DEVELOPMENT MANAGEMENT COMMITTEE

2nd December 2021

21/02639/FUL Construction of 2no. detached dwellings

Land To Rear Of Chertford, 126 Cross Oak Road, Berkhamsted, Hertfordshire, HP4 3NA

Proposed site section drawing showing the elevated position of the application site

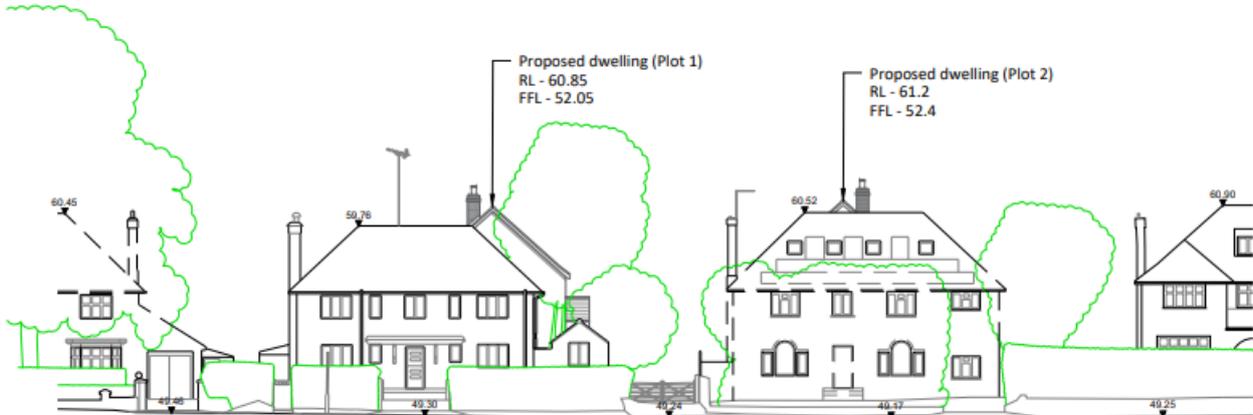
While the proposed buildings would also be set back from the street, given the elevated position of the site, the proposed height of the dwellings (8.97 metres), and the large gap between Dunclutha and Chertford, I believe they would be visible from the street.

Proposed street scene plan showing the height of the new properties behind Chertford and Dunclutha

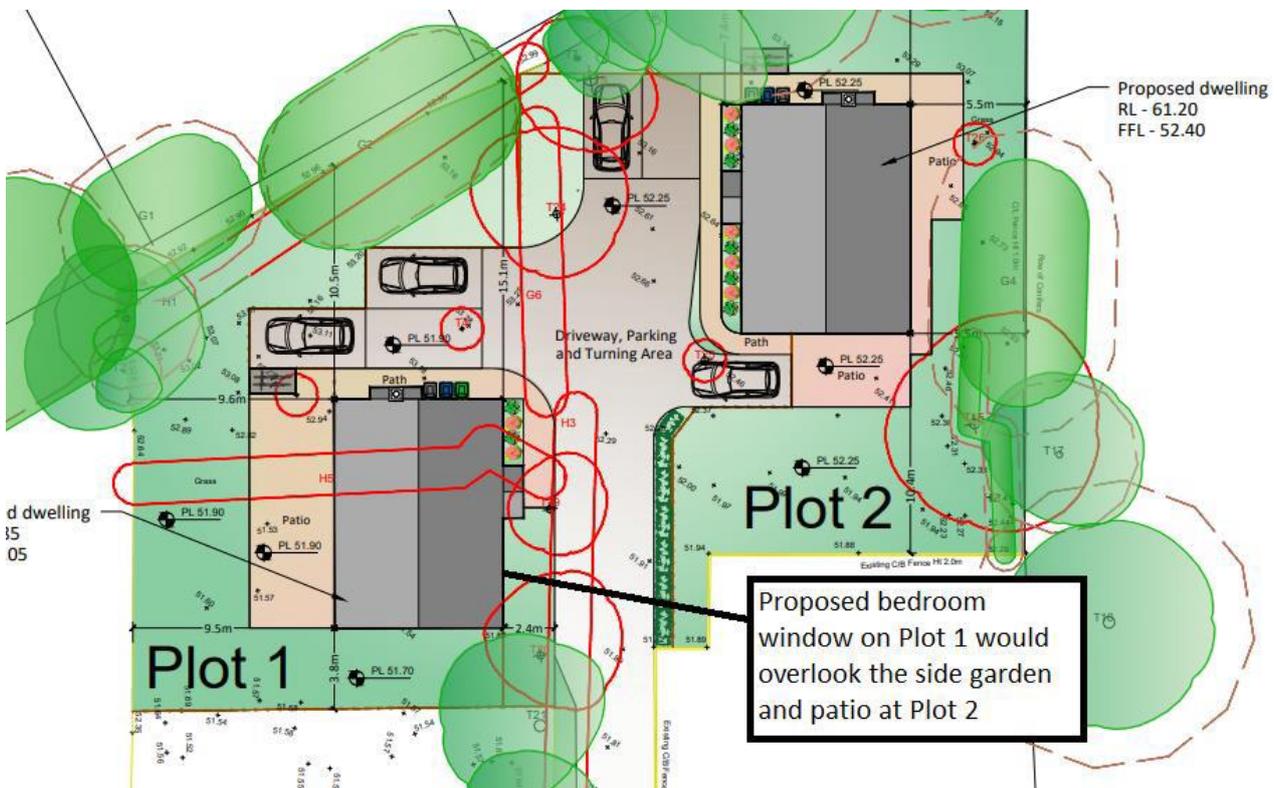
Therefore, unlike the surrounding tandem developments, which are visually discreet, the proposed dwellings would upset the existing pattern and rhythm of development on the street. Furthermore, they could set a harmful precedent for future development of a similar nature in the area.

Land registry plan for Chertford, Cross Oak Road showing position of the boundary

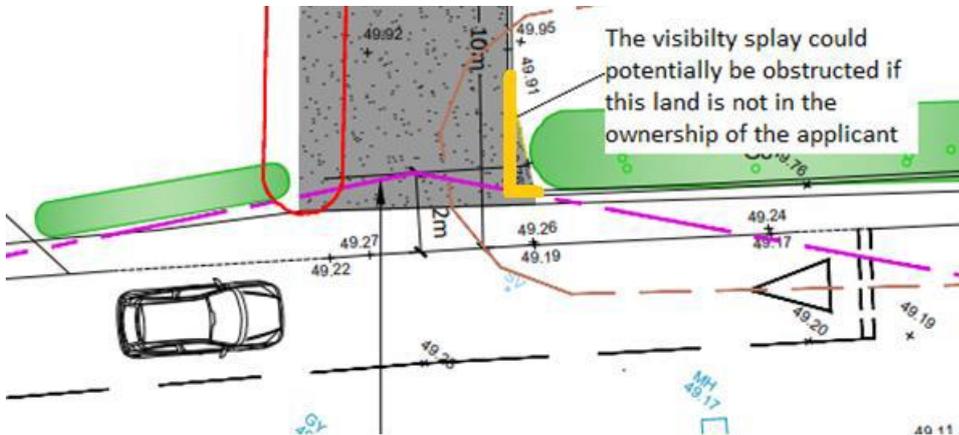
The proposed block plan shows a visibility splay either side of the vehicle access measuring 2 metres x 23 metres. To achieve this the boundary line adjacent to Chertford is angled slightly to make the mouth of the access wider. This angled boundary line has been implemented on site and is visible in the photograph above. My clients believe the position of this boundary could be incorrect, intruding upon land in their ownership.

Below is a copy of the land registry plan for Chertford, provided by my clients. This shows the boundary line between the proposed access and Chertford running straight to the front of the site, not at angle.
